Product Brand: Roto Solid

Phase out Solid C chanceover HVM and silver R011

The main door hinges listed below have been or will be changed to a new variant.
For detailed information on the replacement, please refer to the enclosed presentation.

Roto Solid C | innen öffnend – HVM II

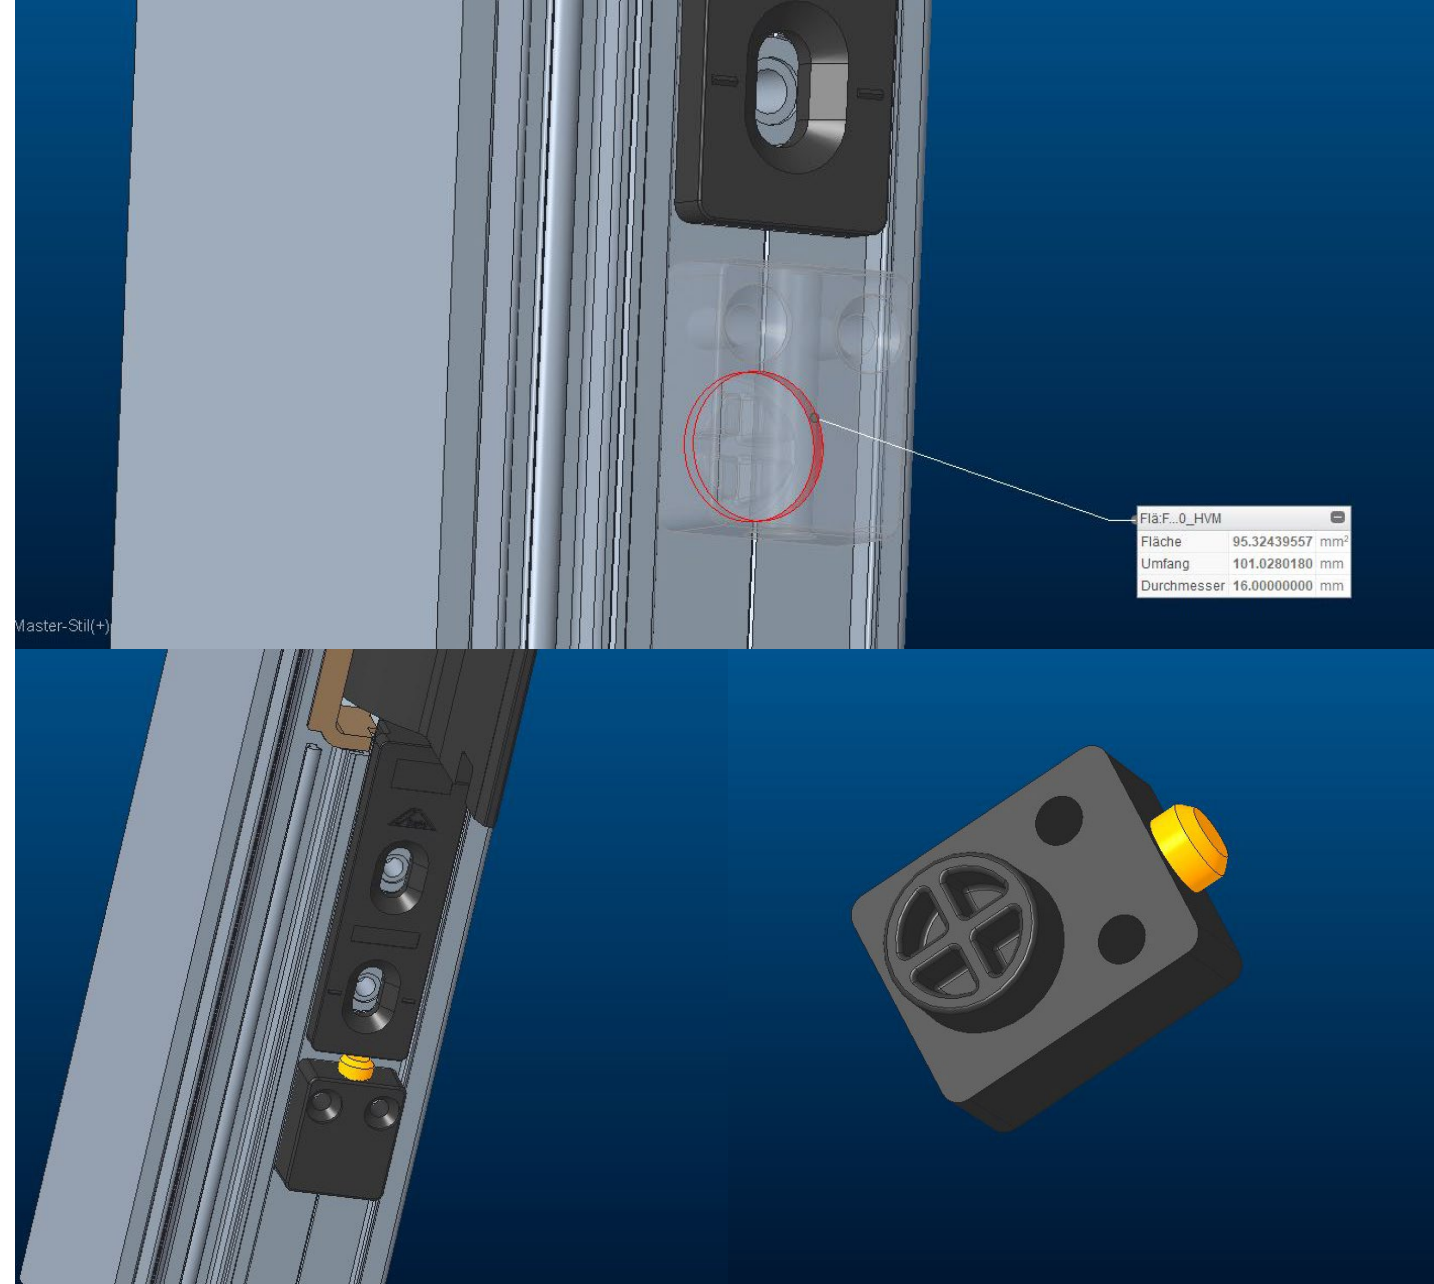
- Optische Anpassung an das Rahmenband
 - Einfache Bearbeitung: Bohrung \varnothing 16 mm statt Fräsung
 - Einfache Montage: vormontiert ab Werk, 2 Befestigungsschrauben im Lieferumfang enthalten
 - Weniger Teile: Direktbefestigungsschraube und Abdeckung entfallen
 - Preisvorteil: HK-Senkung um ca. 35%
-
- Start Anfang 2022 mit Kompotherm
 - Schrittweise Umstellung aller Kunden im Laufe des Jahres

Roto Solid C | inward opening – HVM II

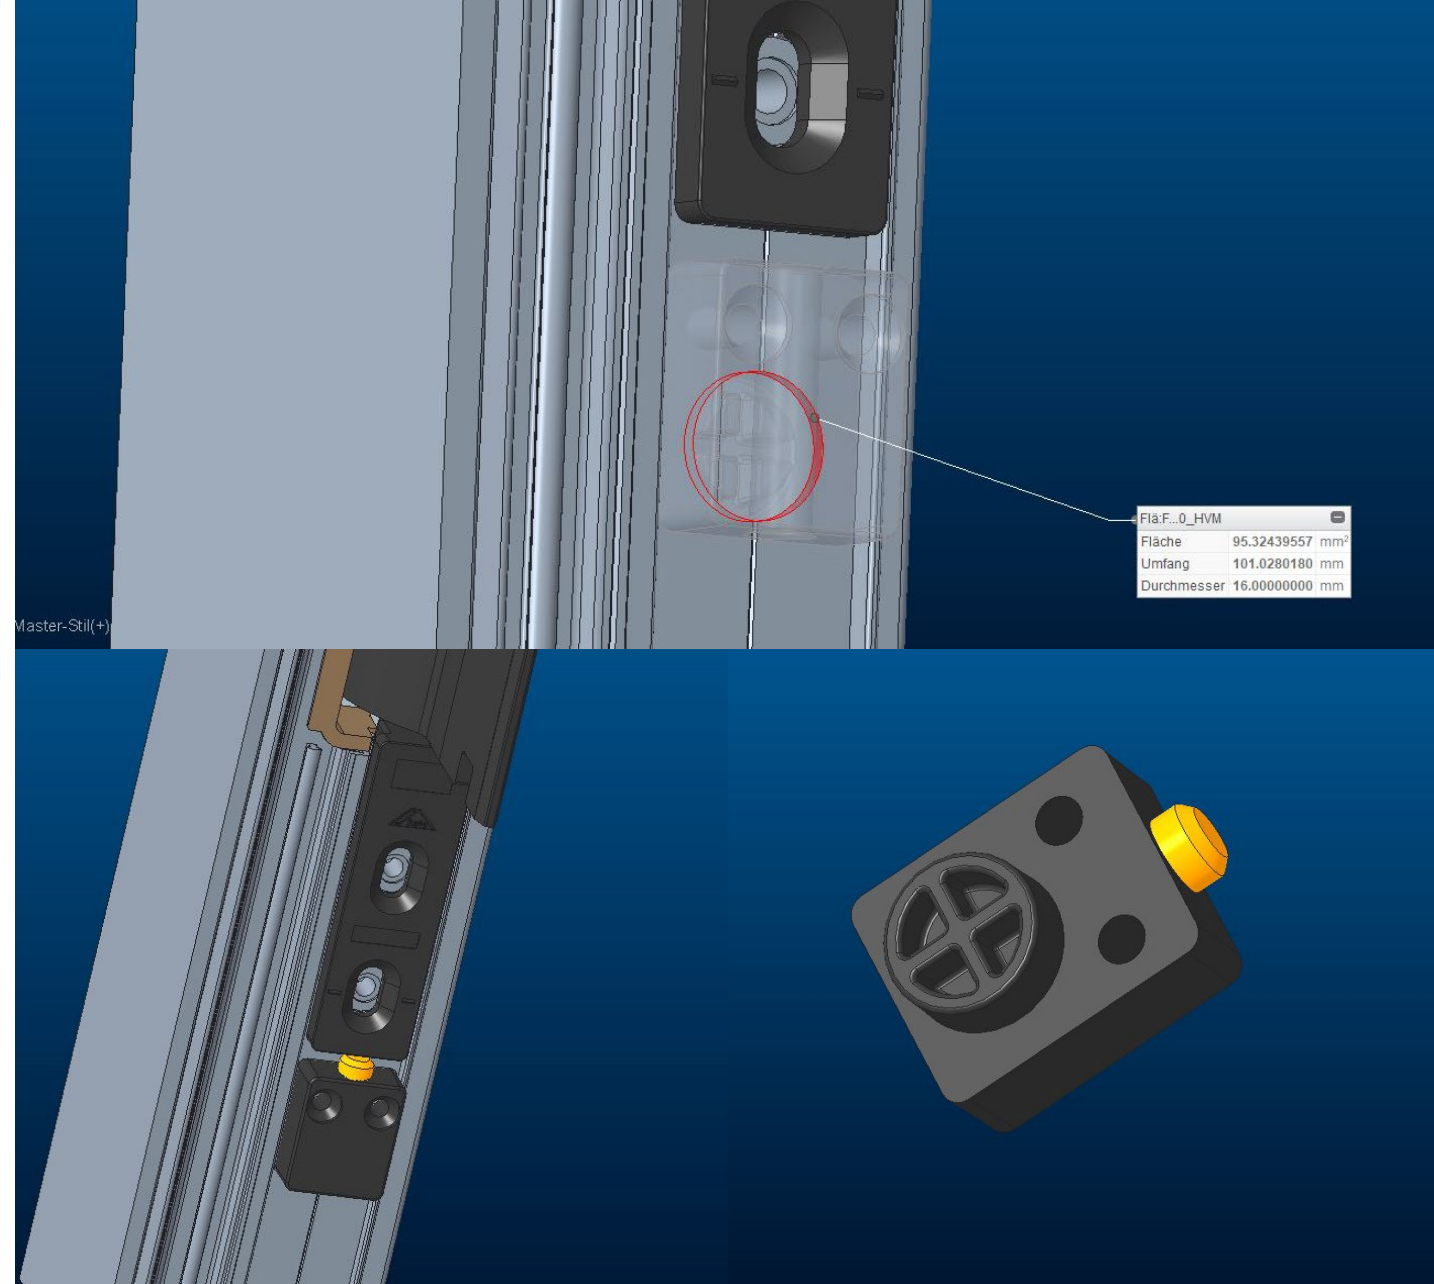
- Optical adaptation to the frame hinge
 - Easy processing: Ø 16 mm hole instead of milling
 - Easy assembly: pre-assembled ex works, 2 fixing screws included in delivery
 - Fewer parts: Direct fixing screw and cover cap not required
 - Price advantage: HK reduction of approx. 35%
-
- Starting in early 2022 with Kompotherm
 - Gradual changeover of all customers during 2022
